March 2023
FL964 A
NHTSA #23V-063
Transport Canada #2023-046

Subject: Freightliner Coronado Upper Bunk Wall Mounting

Work Instructions

Upper Bunk Mounting Fastener Replacement

Fig. 2, Old Fastener and Nut

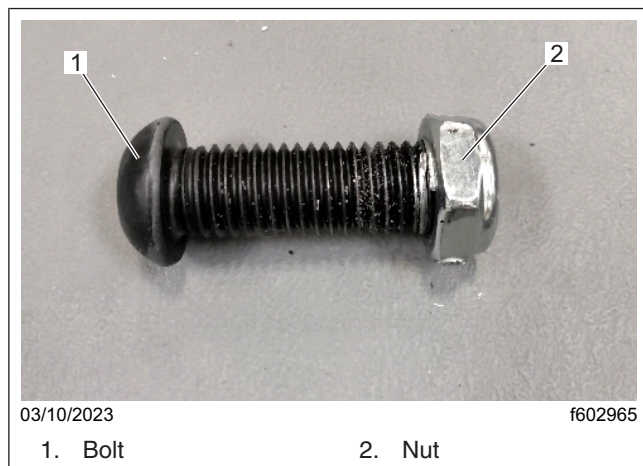
5. Remove the pivot fastener and nut. See [Fig. 2](#).
6. Install the new fastener and nut. Tighten the nut 50 lbf-ft (68 N·m). See [Fig. 3](#) and [Fig. 4](#).
